**INTEGRATED CIRCUITS, SILICON MONOLITHIC,  
HEX BUS DRIVER WITH 3-STATE OUTPUTS,  
BASED ON TYPE 54LS367A  
ESA/SCC Detail Specification No. 9202/054**

| Issue/Rev.   | Date         | Approved by   |                                       |
|--------------|--------------|---------------|---------------------------------------|
| Issue 4      | January 1994 |               |                                       |
| Revision 'A' | January 1995 |               |                                       |

**DOCUMENTATION CHANGE NOTICE**

**FIGURE 2 - PHYSICAL DIMENSIONS**

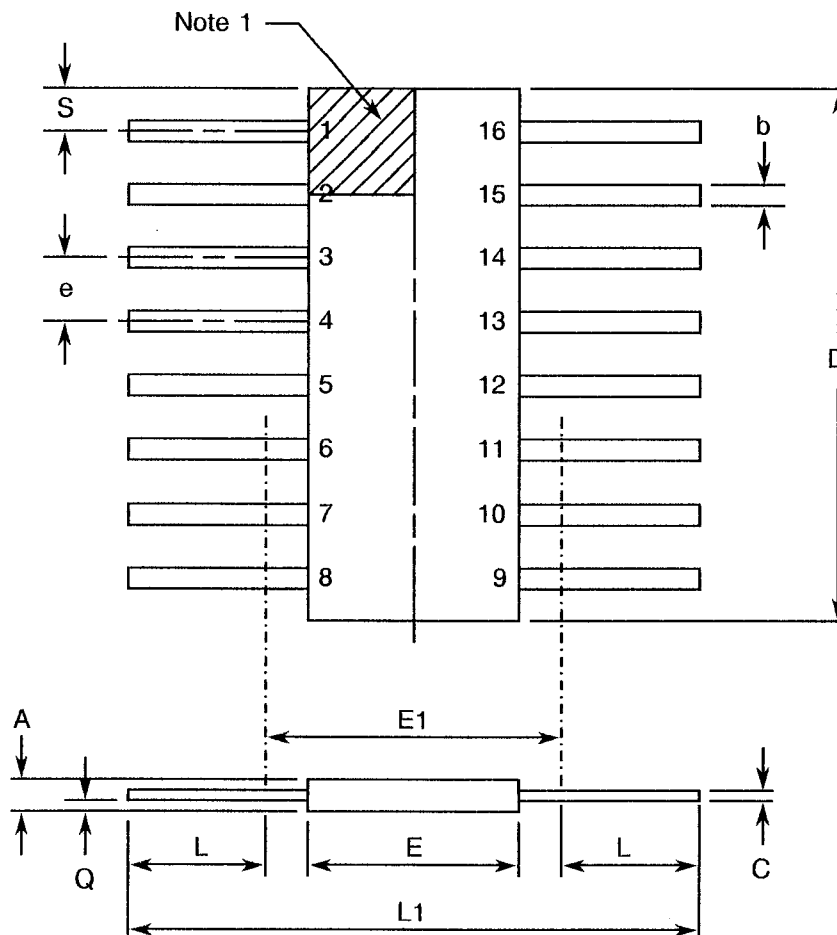
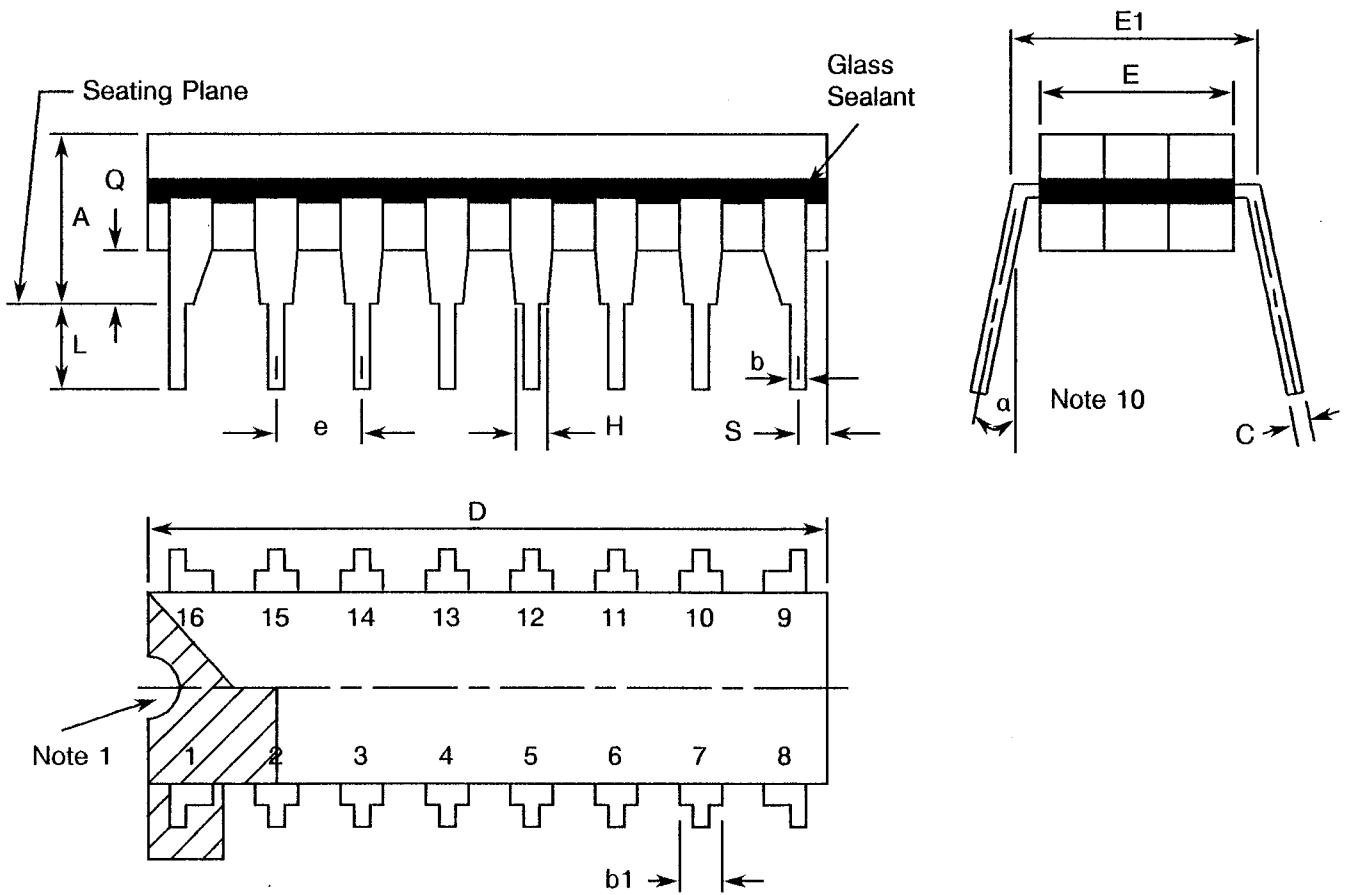
| Rev. Letter | Rev. Date | Reference   | CHANGE Item  | Approved DCR No. |
|-------------|-----------|---|--|------------------|
|             |           | Figures 2(a), (b)   | : Drawing and Table amended  | 221033           |
|             |           | Figures 2(a), (b), (c)  | : Imperial dimensions deleted  | 22881            |

**FIGURE 2(b) - DUAL-IN-LINE PACKAGE**

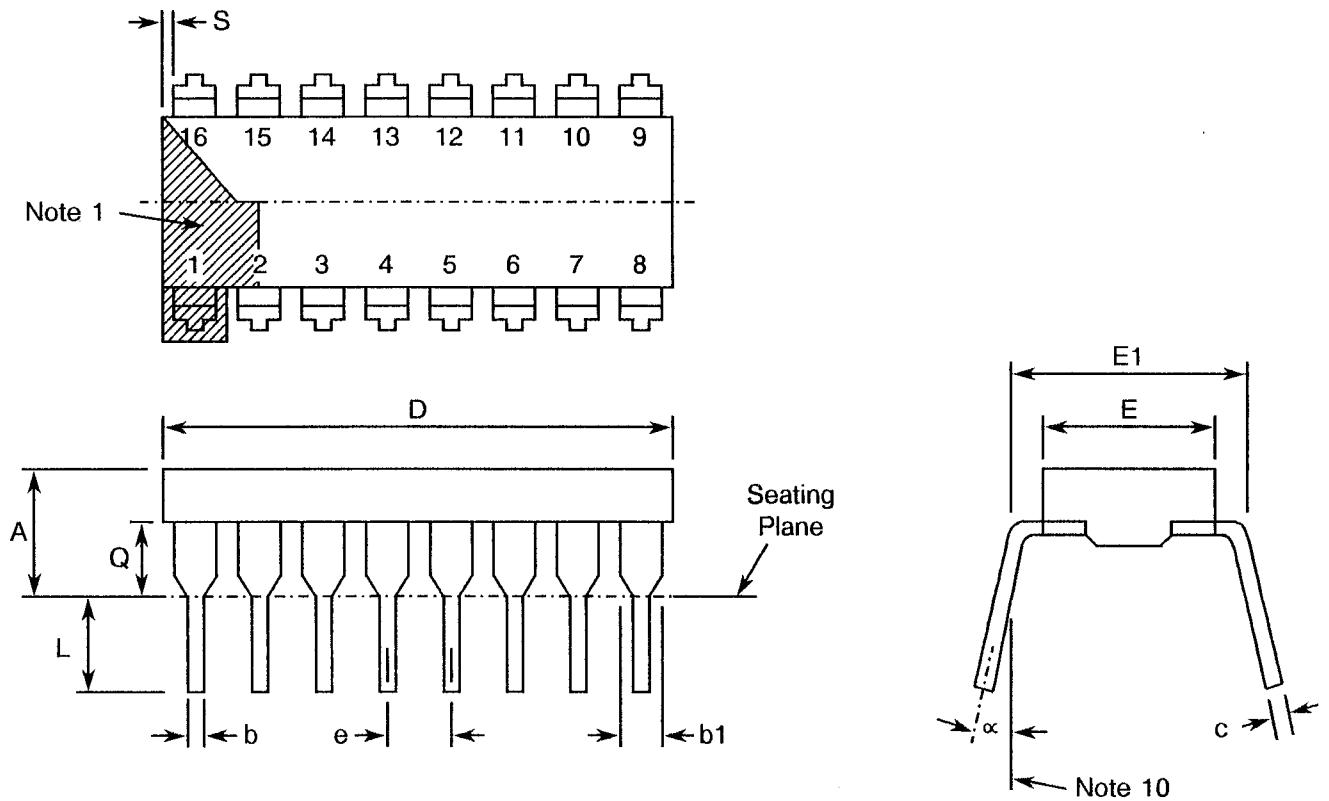
| Rev. Letter | Rev. Date | Reference   | CHANGE Item  | Approved DCR No. |
|-------------|-----------|---|--|------------------|
|             |           | Figures 2(b), (c)   | : Reference to Note 6 amended to "Note 10"   | 23519            |

**FIGURE 2(d) - SQUARE CHIP CARRIER PACKAGE (3 LAYER BASE)**

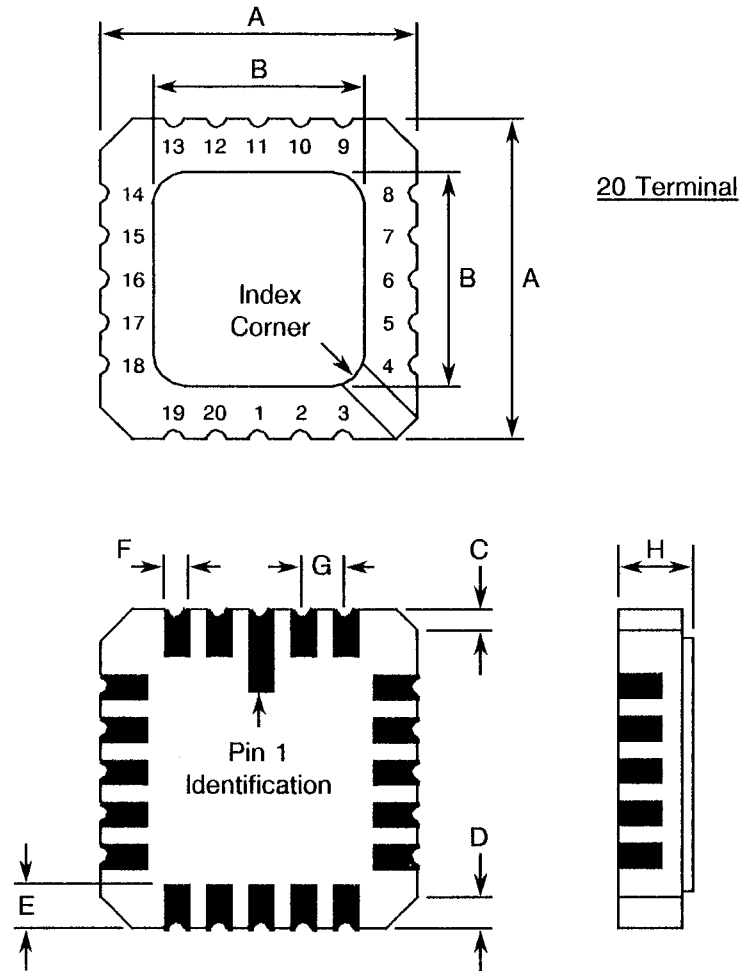
| Rev. Letter | Rev. Date | Reference   | CHANGE Item  | Approved DCR No. |
|-------------|-----------|---|--|------------------|
|             |           | Figure 2(d)   | : New figure added   | 22881            |

**FIGURE 3(a) - PIN ASSIGNMENT**

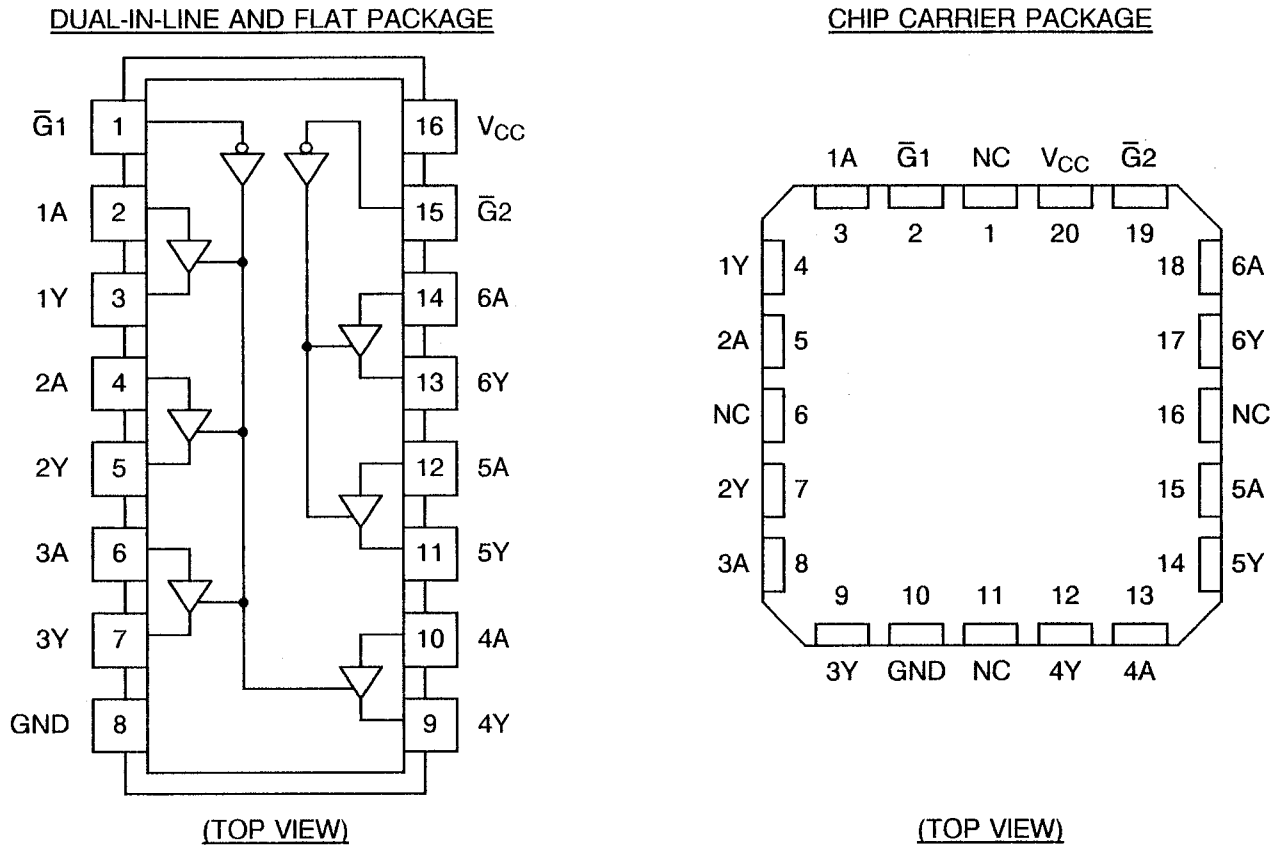
| Rev. Letter | Rev. Date | Reference   | CHANGE Item  | Approved DCR No. |
|-------------|-----------|---|--|------------------|
|             |           | Figure 3(a)   | : Figure for chip carrier package added  | 22881            |
|             |           |   | : Subtitles added above both drawings  | 22881            |
|             |           |   | : Comparison table added   | 22881            |
|             |           |   | : Note 1 added   | 22881            |

**FIGURE 3(b) - TRUTH TABLE**

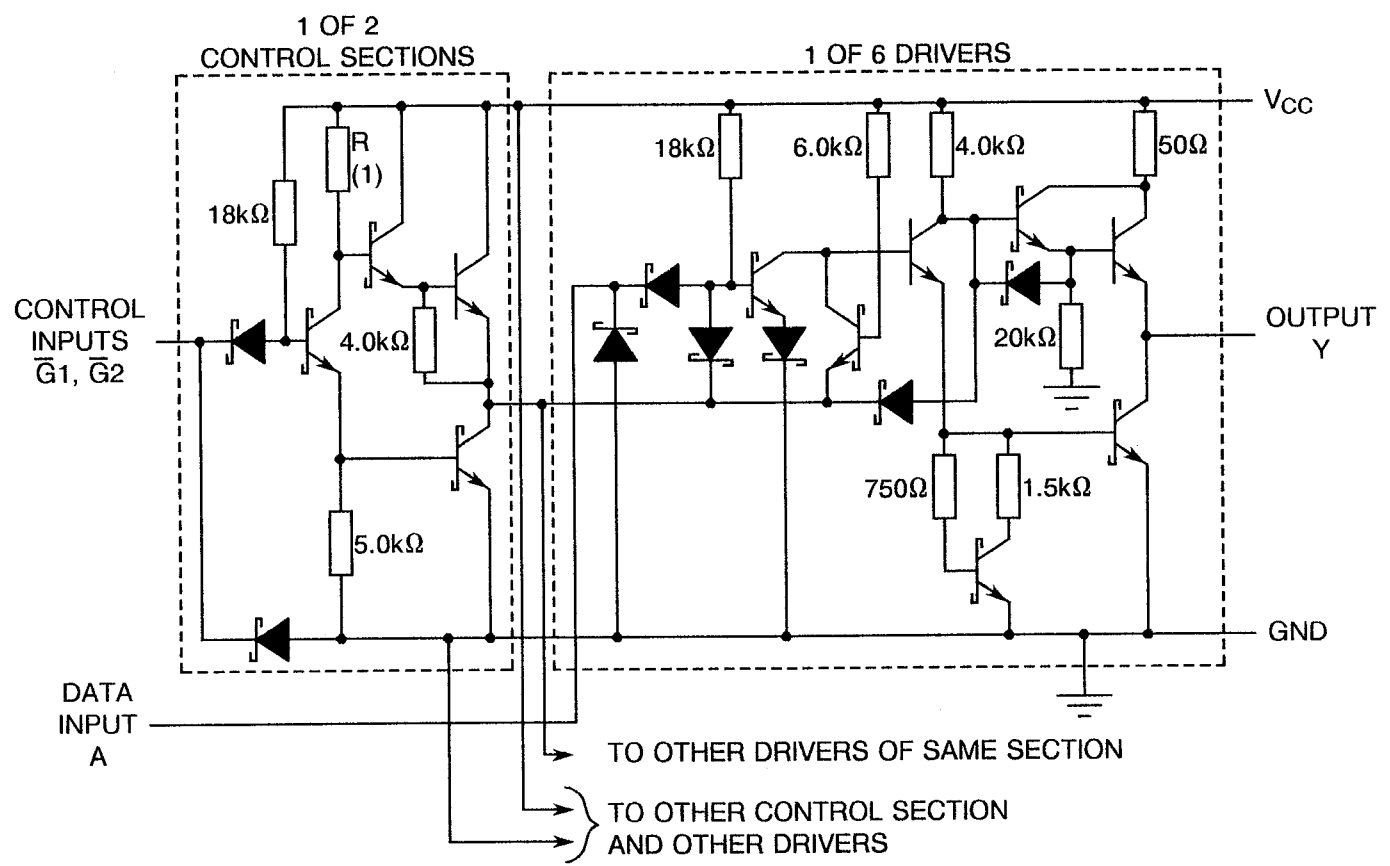
| Rev. Letter | Rev. Date | Reference   | CHANGE Item  | Approved DCR No. |
|-------------|-----------|---|--|------------------|
|             |           | Figure 3(b)   | : Note added   | 23519            |
